Amendments to the Drawings:

Remarks/Arguments

PA69/MII-29-11-03 (45223-P007US)

Fig. 7

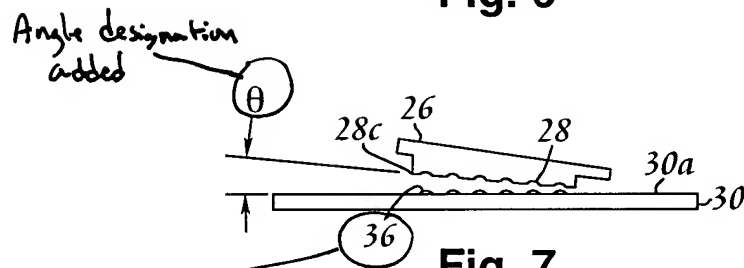
The Examiner has objected to the drawings because: "Fig. 7 has unidentified lumps on the surface (30a) and are somewhat unclear due to the poor or rough quality of the drawings." Office Action, at 3.

The attached sheer of drawings includes changes to Fig. 7. This sheet, which includes Figs. 6-8, replaces the original sheet including Figs. 6-8. In Fig. 7, previously unnumbered element 36 has been so numbered.

Applicant has herein amended Fig. 7 to properly number droplets 36 on the surface 30a. See attached replacement drawing sheet.

numbering
of droplets
36 added
